Access Compliance Report

Public Rights-of-Way

(Curb Ramps)

Intersection ID: 52918	Main Street: HOOVER_CREEK_BV	Cross Street: STEELE_CREEK_RD	Location: SW
ADA ID: E9F72EAC54CB	Ramp Type: PerpDiag	Initial Pass/Fail: Fail	Overall Compliance: No
Severity Score: 10			
Codes/Mitigation Info/Possible Solution		Field Measurements/Component Compliance

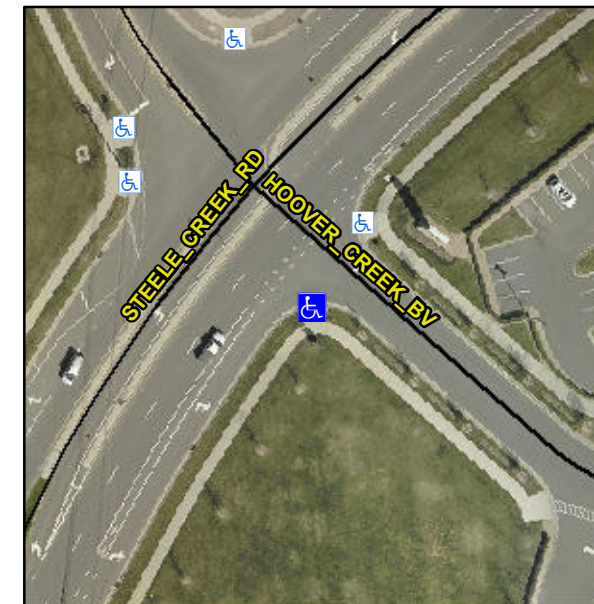
Not Found, R304.5.1, R304.5.3

Compliance	Description	Data	Compliance	Description	Data
N/A	Ramp Length (in)	96.0	Yes	Ramp Slope (%)	6.5
No	Ramp Width (in)	46.0	No	Ramp XSlope (%)	3.6
N/A	Flare Type LT	N/A	N/A	Flare Type RT	N/A
N/A	Flare Slope LT (%)	N/A	N/A	Flare Slope RT (%)	N/A
N/A	Flare Traversable LT?	N/A	N/A	Flare Traversable RT?	N/A
N/A	Landing Length (in)	N/A	N/A	DWS Provided?	N/A
N/A	Landing Width (in)	N/A	N/A	DWS Contrast?	N/A
N/A	Landing Slope (%)	N/A	N/A	DWS Length (in)	N/A
N/A	Landing X Slope (%)	N/A	N/A	DWS Full Width?	N/A
N/A	Landing Curb? (Y/N)	N/A	N/A	DWS Offset (in)	N/A
N/A	Shared Landing?	N/A			
N/A	Gutter Ponding?	N/A	N/A	Gutter Slope (%)	N/A
N/A	Gutter Lip Ht (in)	N/A	N/A	Gutter X Slope (%)	N/A
N/A	Painted X Walk1?	No	N/A	Painted X Walk2?	No
	X Walk 1 Direction	To NE		X Walk 2 Direction	To NW
N/A	X Walk 1 Width (in)	N/A	N/A	X Walk 2 Width (in)	N/A
	X Walk 1 Slope (%)	3.0		X Walk 2 Slope (%)	3.3
	X Walk 1 X Slope (%)	1.0		X Walk 2 X Slope (%)	5.4

Remove & Replace Curb Ramp With Two New Directional Ramps or Equivalent.
